ARCHITECT'S ADDENDUM

Addendum Number: 004

RE: EASD #131 East Aurora High School
2027 Mechanical Improvements

Subject: Addendum No. 004 to the Construction Documents for the EASD #131 East Aurora High School 2027 Mechanical Improvements Project.

C-A2.31

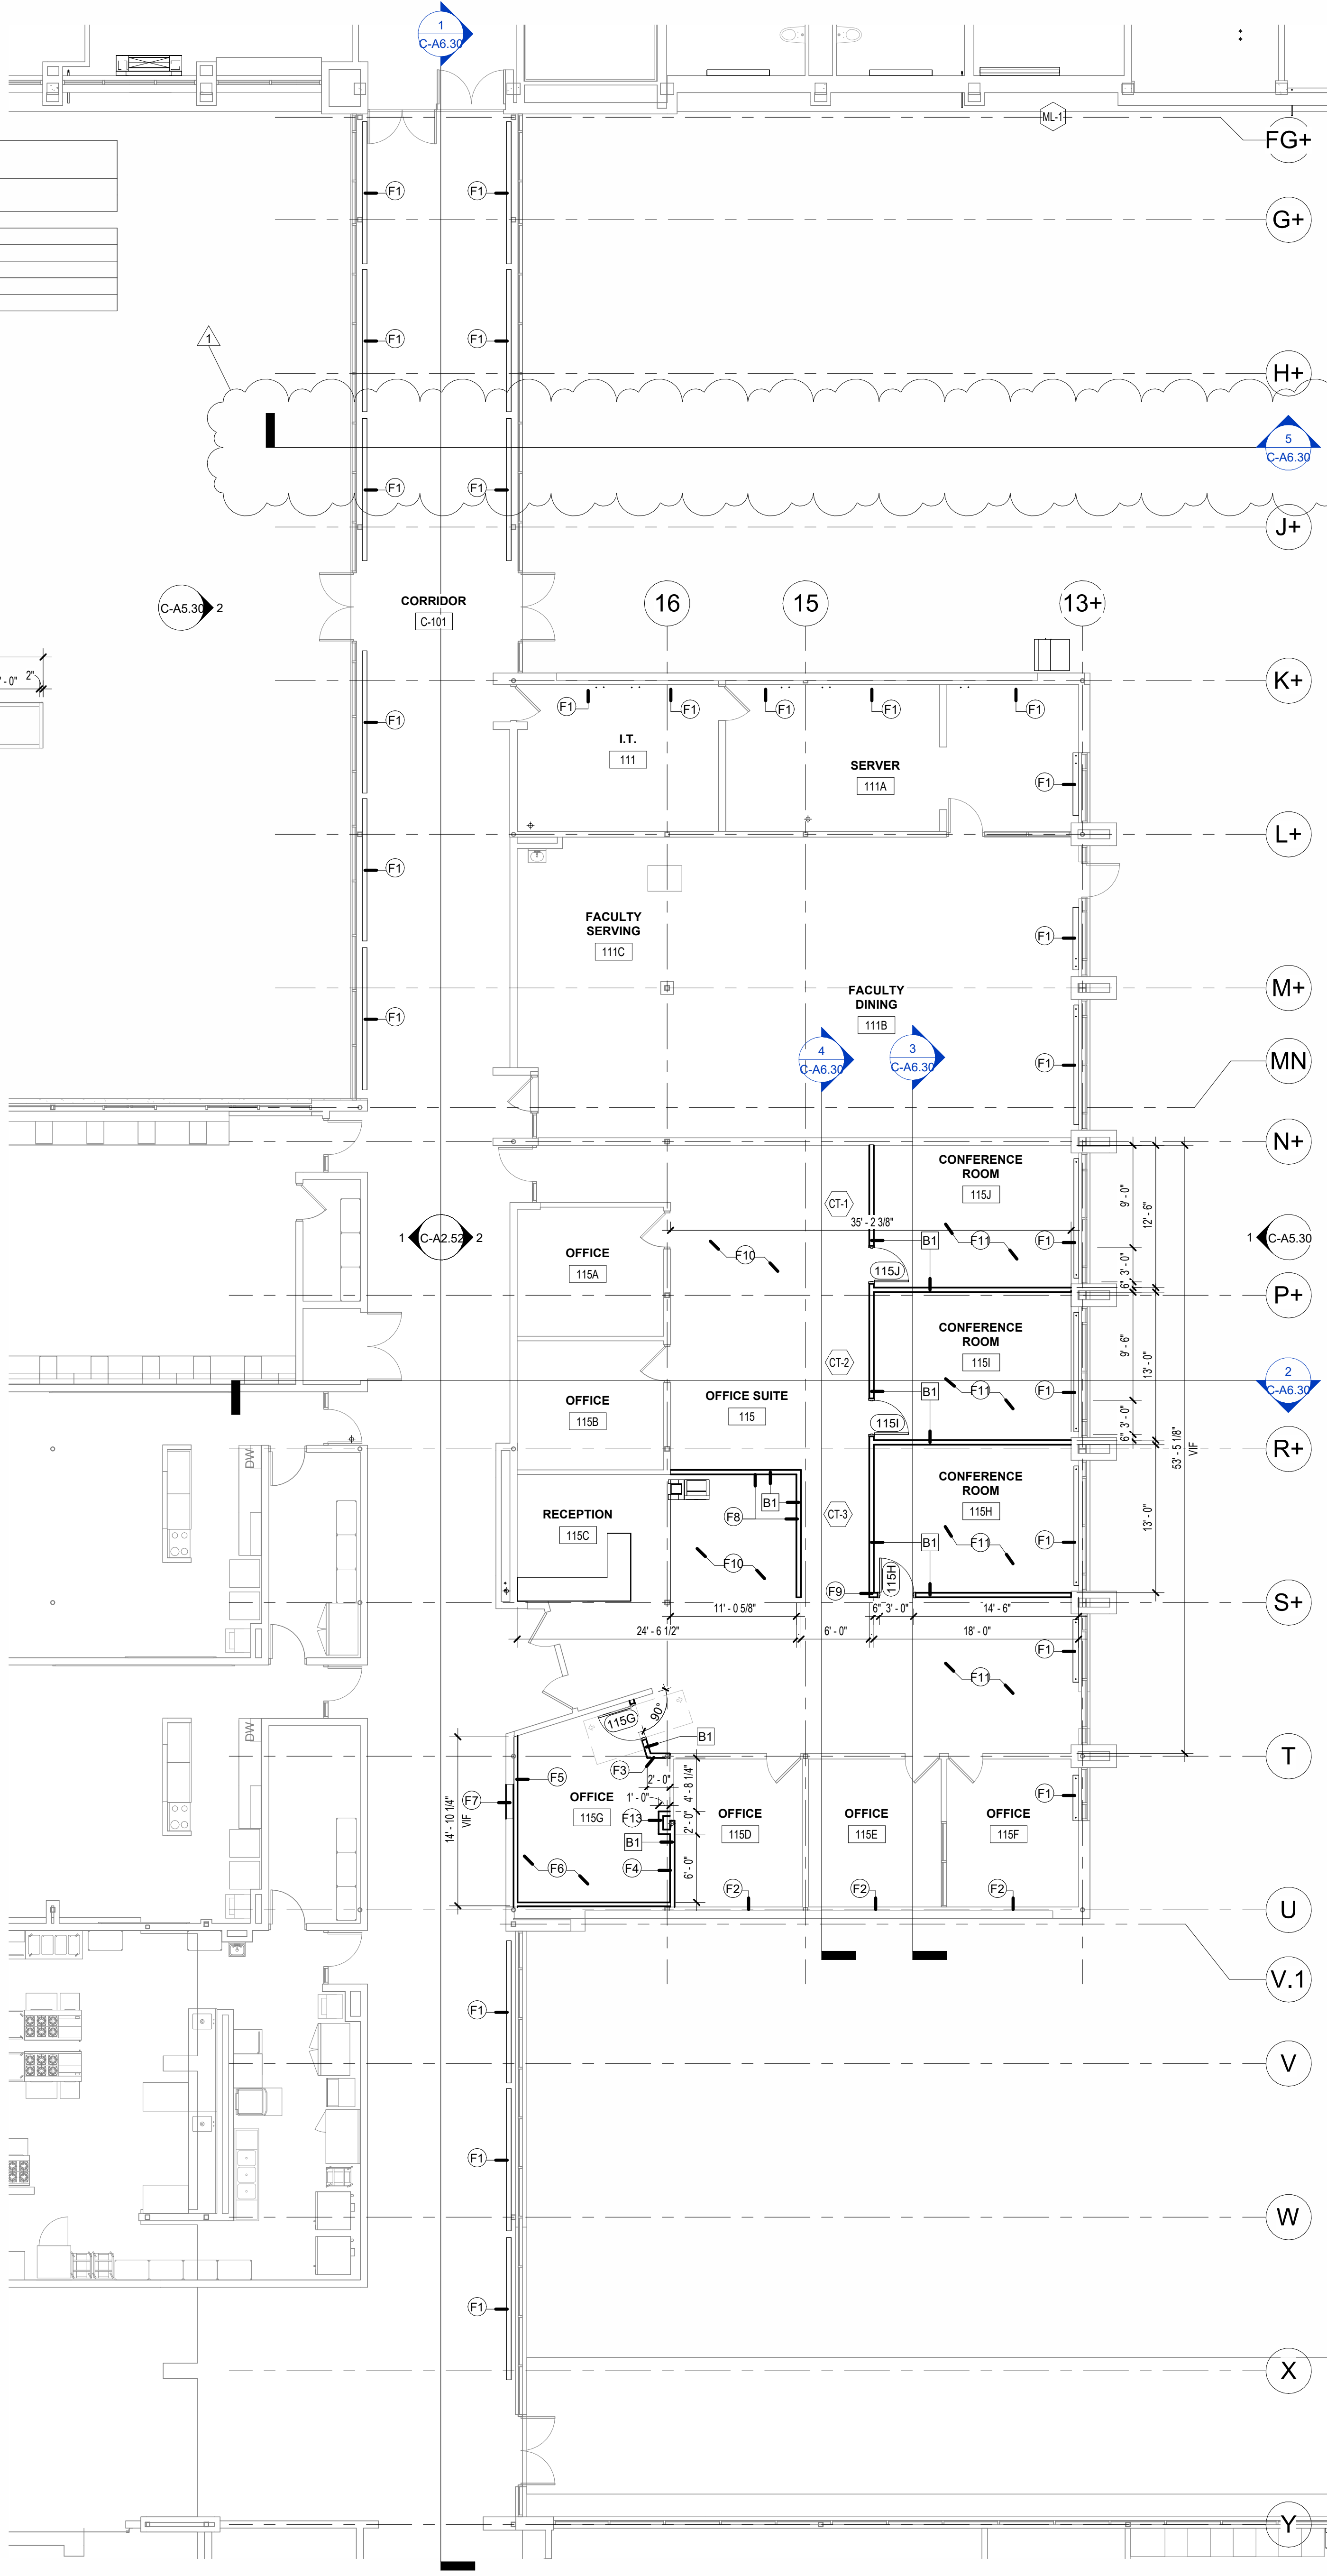
1. C-A2.31 – AREA C – FIRST FLOOR PLAN

- **REPLACE** sheet in its entirety.
- **REVISED** Floor Finish Legend, Carpet Tile (CPT-1) has been changed to Luxury Vinyl Tile (LVT-1). Room Finish Schedule and Finish Material Legend have been updated to reflect this change.
- LVT-1 – Manufacturer: J+J Flooring, Style: Classics V5000, Color: Archetype 1001, Size: 9" x 48".

R-4.00

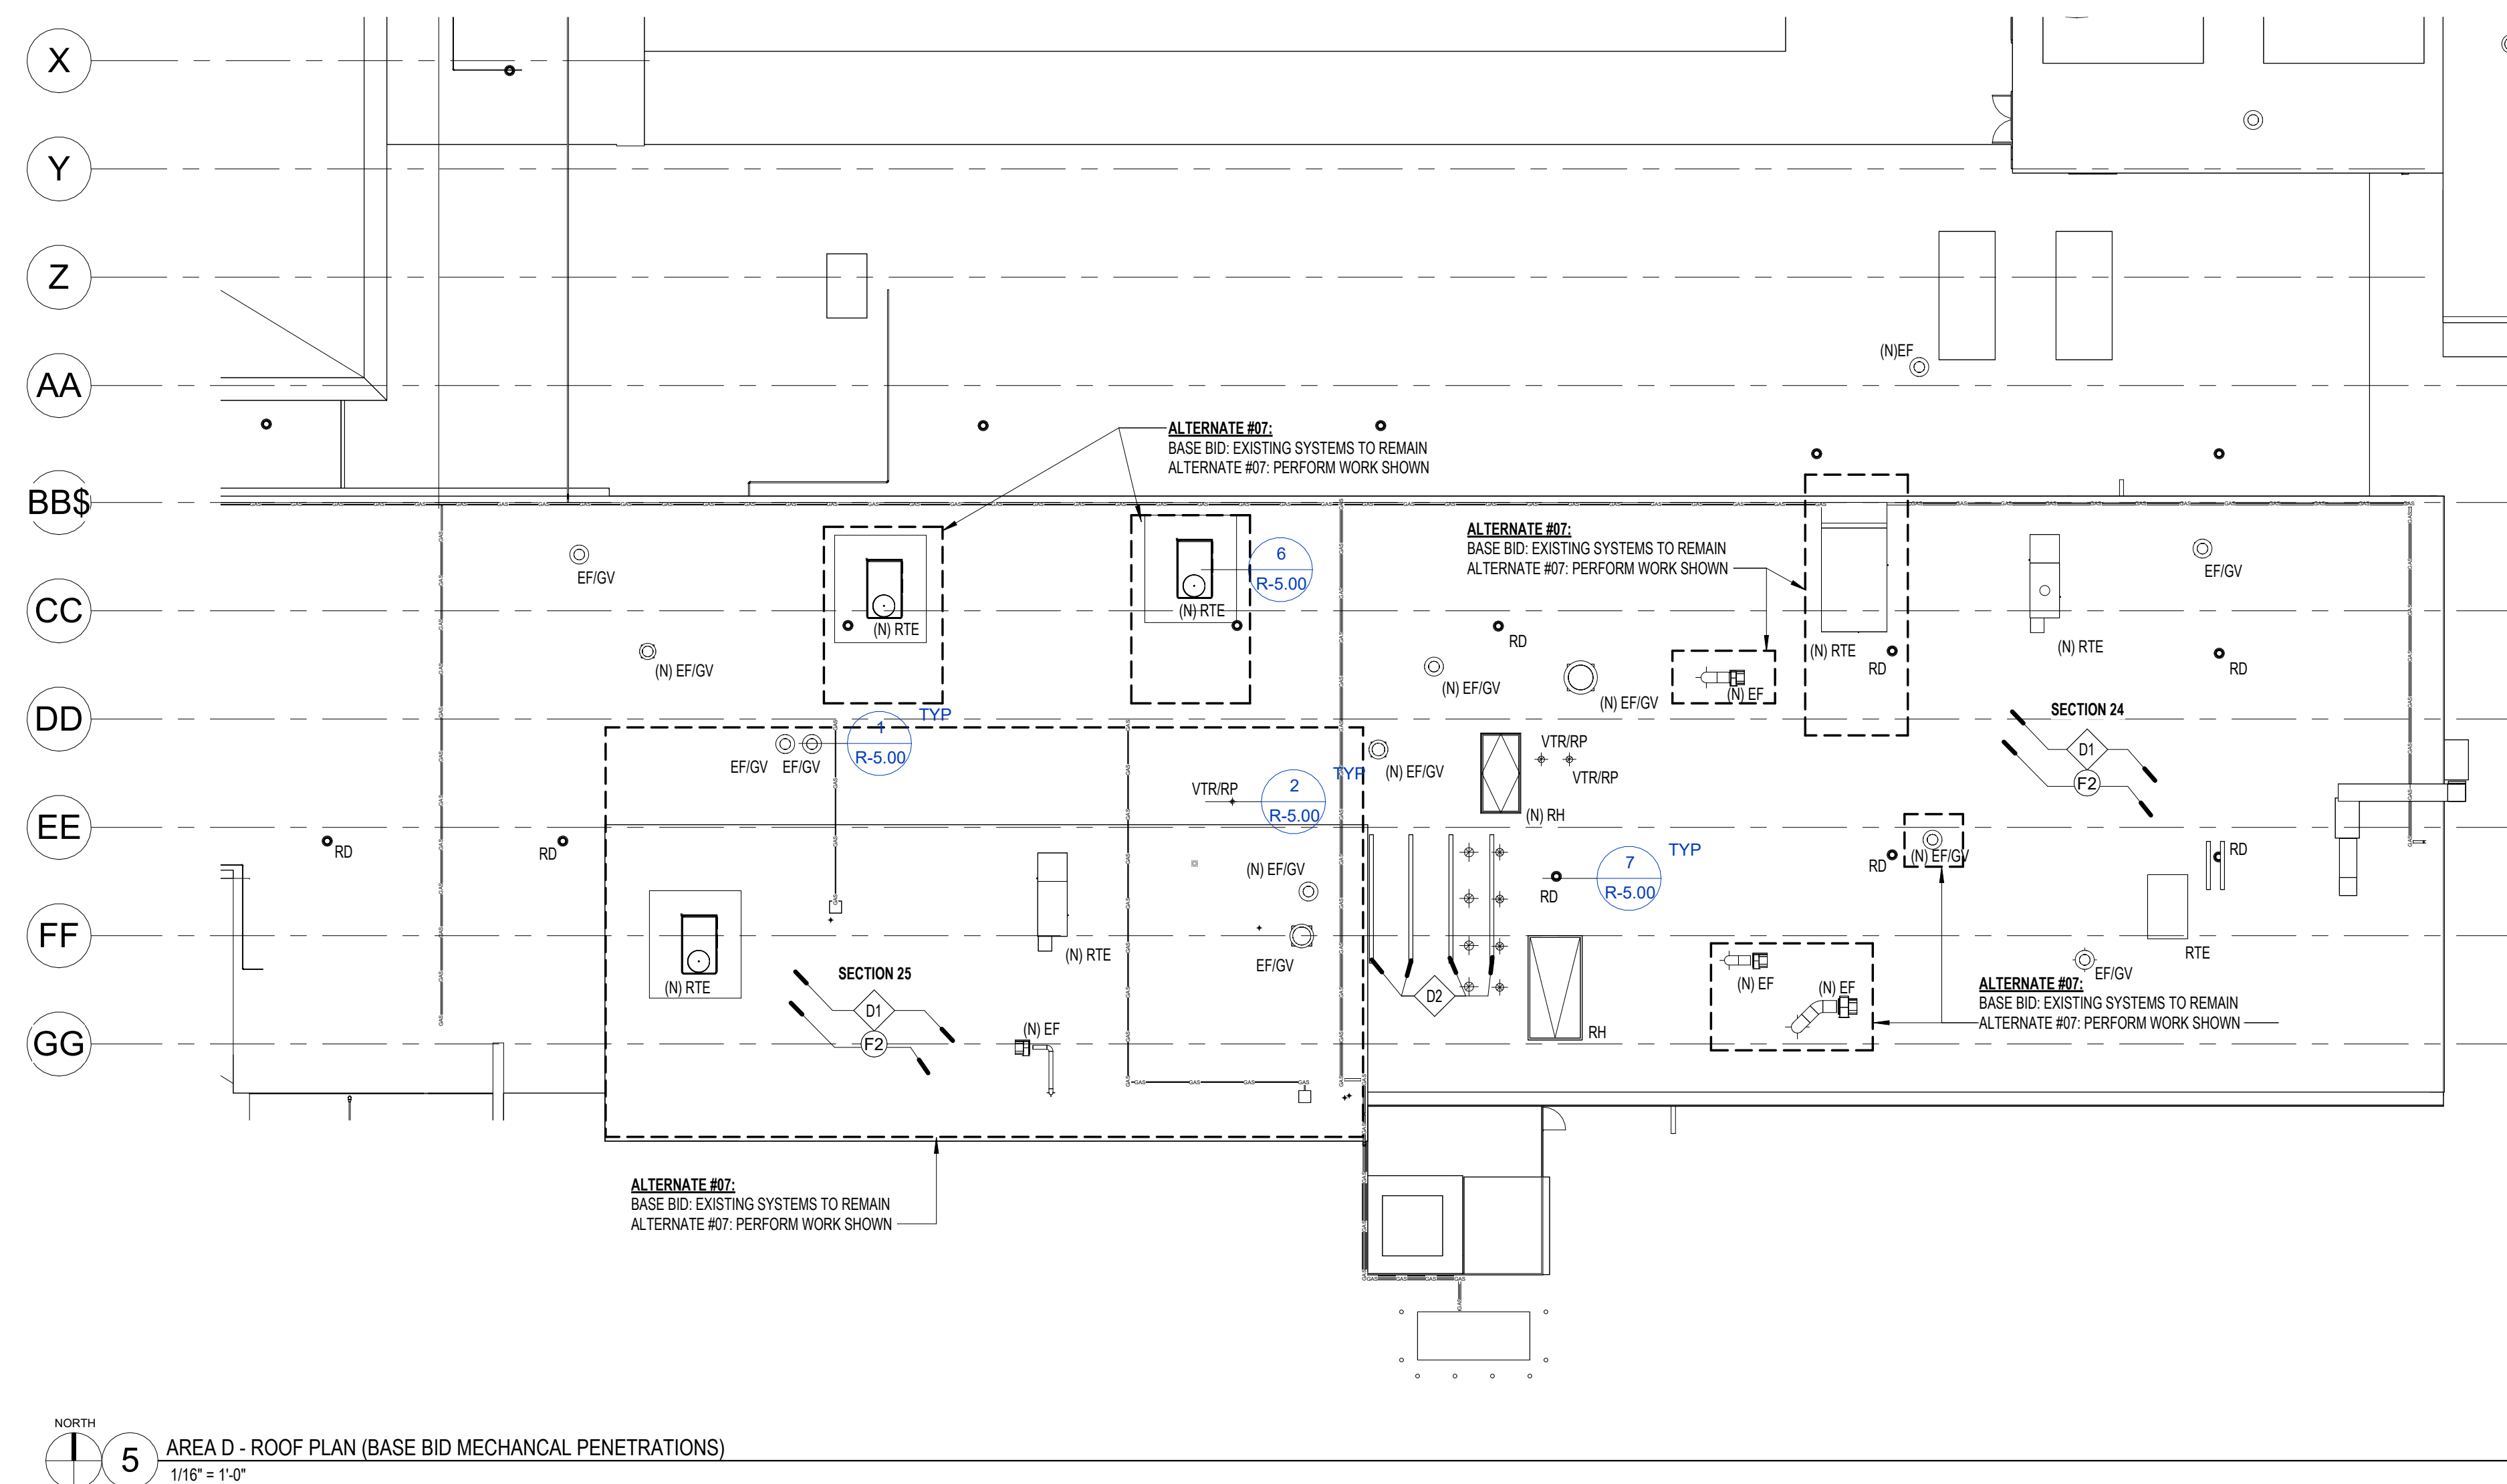
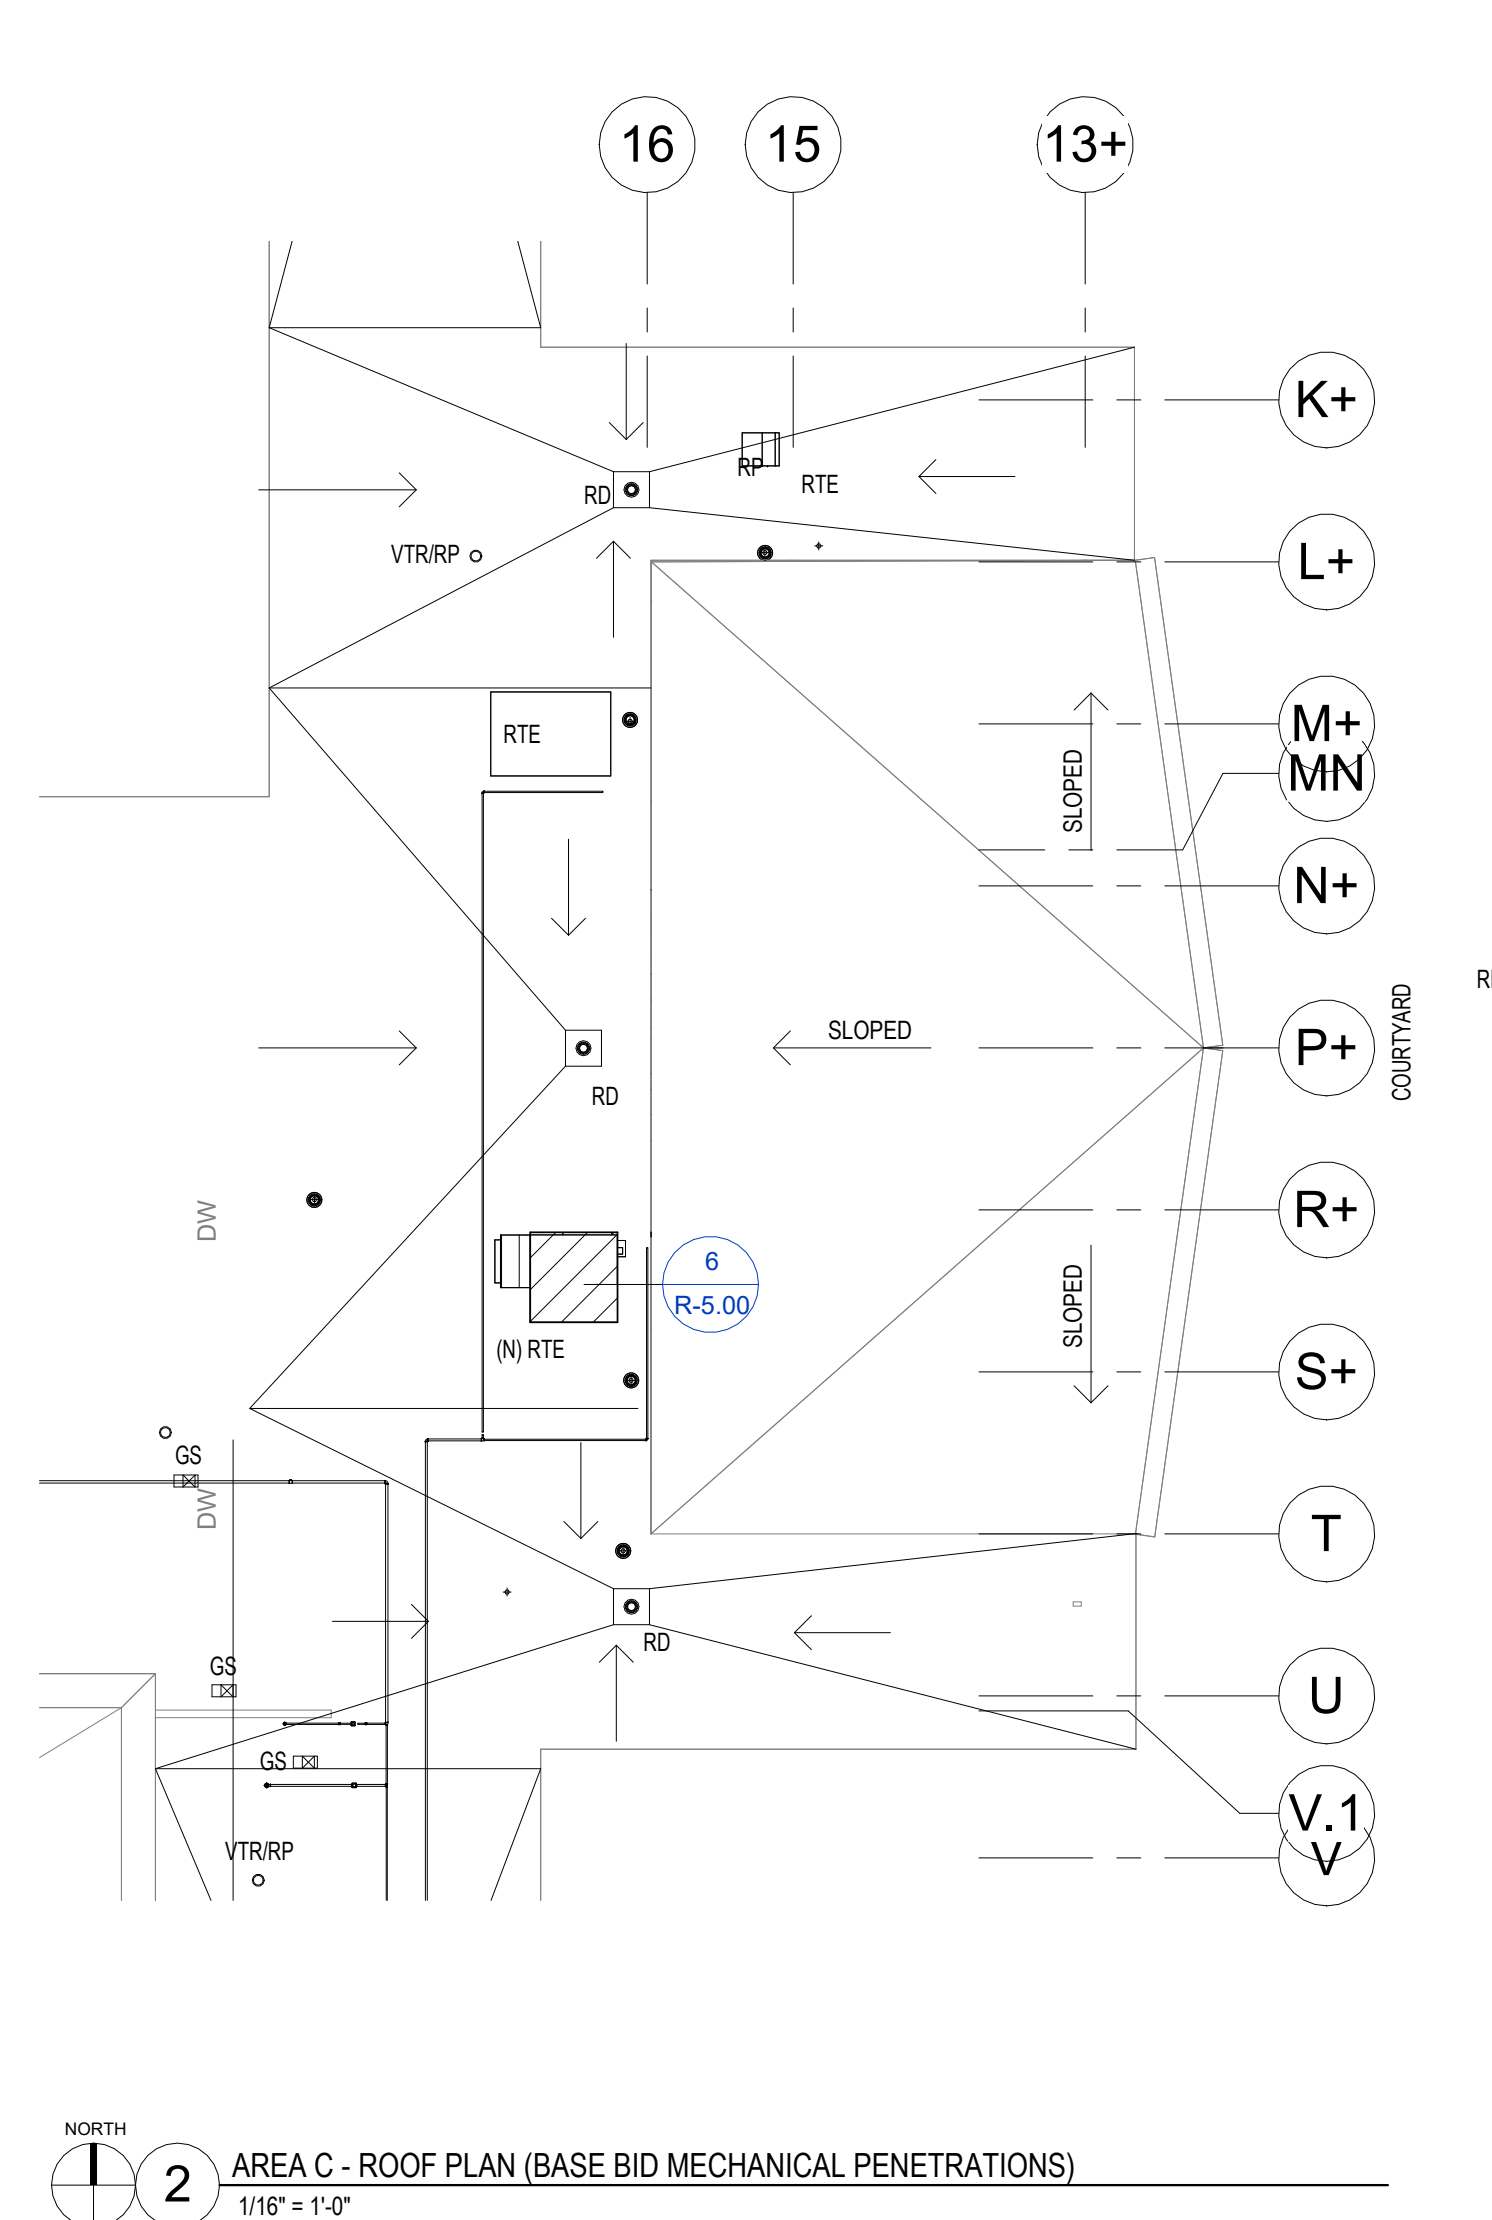
2. R-4.00 – ROOF PLANS – BASE BID

- **REPLACE** sheet in its entirety.
- **REVISED** Roof Demolition Keynotes
- **REVISED** Roofing Keynotes
- **ADDED** New Roof Construction Legend
